FOUNDATION INVESTIGATION REPORT
For
Proposed New Bridge on Hwy. #31 and
Hess (Branch) Creek - South Crossing,
County of Dundas, Twp. of Williamsburg,
Lot 30, Conc. 7, District #9 (Ottawa).
W.J. 65-F-91 -- W.P. 219-64

FOUNDATION INVESTIGATION REPORT

Proposed New Bridge on Hwy. #31 and
Hess (Branch) Creek - South Crossing,
County of Dundas, Twp. of Williamsburg,
Lot 30, Conc. 7, District #9 (Ottawa).

Highway 31 & Hess Creek, V.P. 219-64 & V.P. 319-64
Preliminary Plans #D5839-1 & D5863-P1

GENERAL PLAN

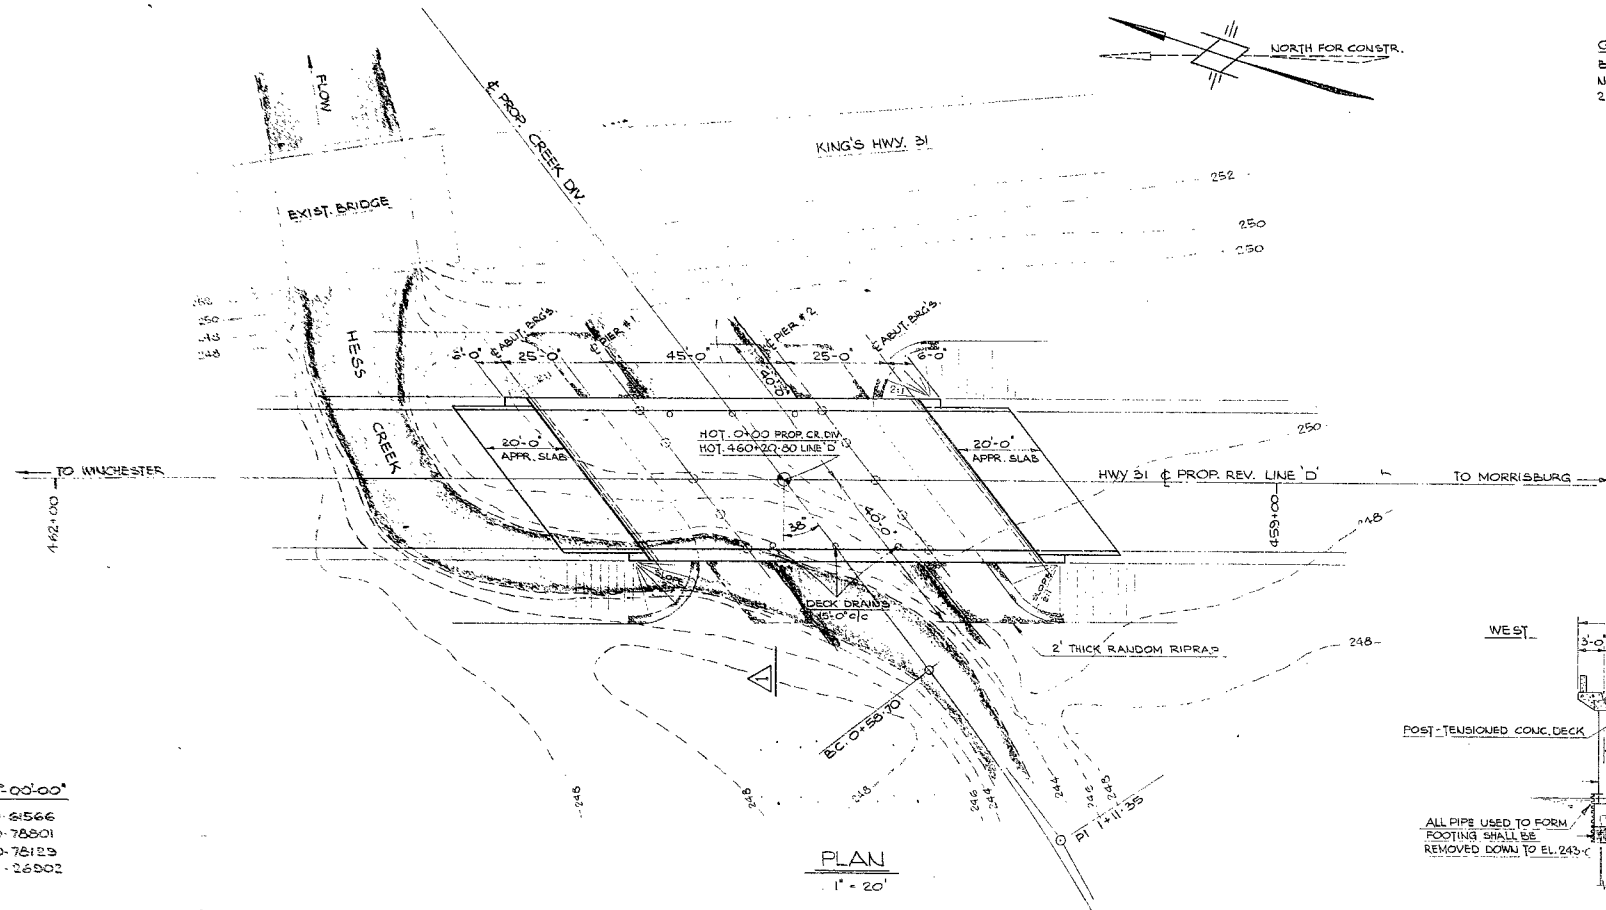
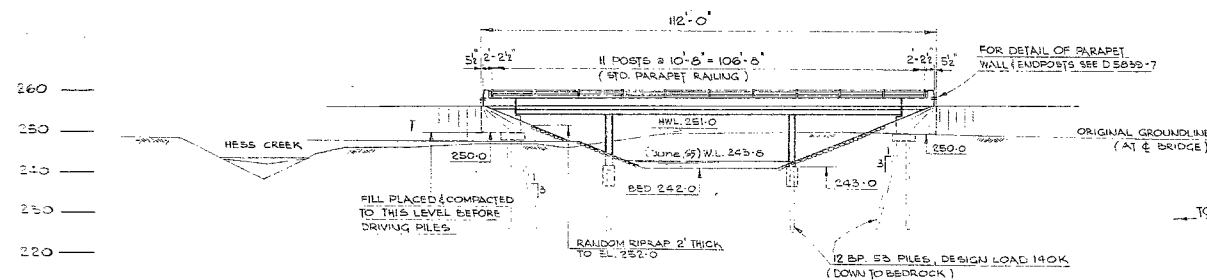
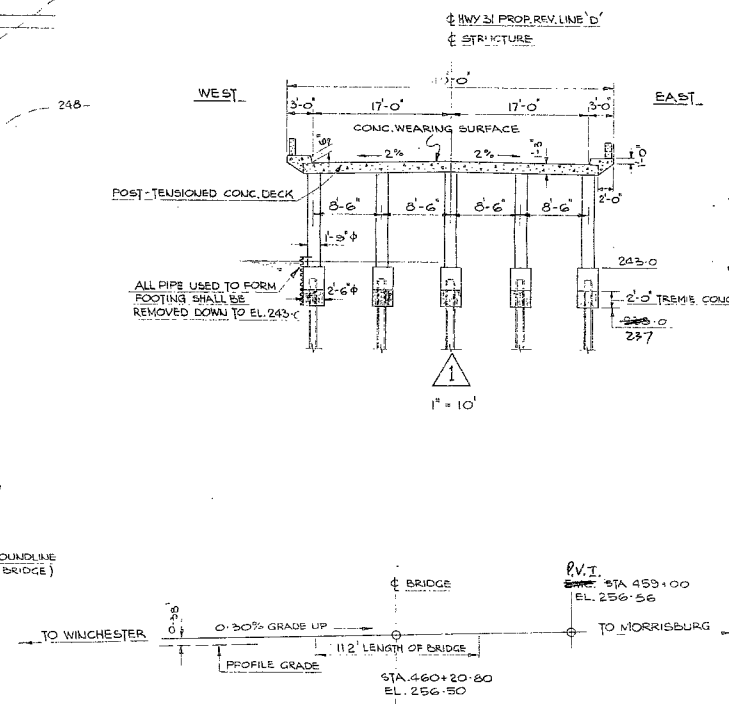
We have reviewed the above-mentioned preliminary plans with regard to the foundation design. We note that the designer has complied with the recommendations contained in the foundation reports.
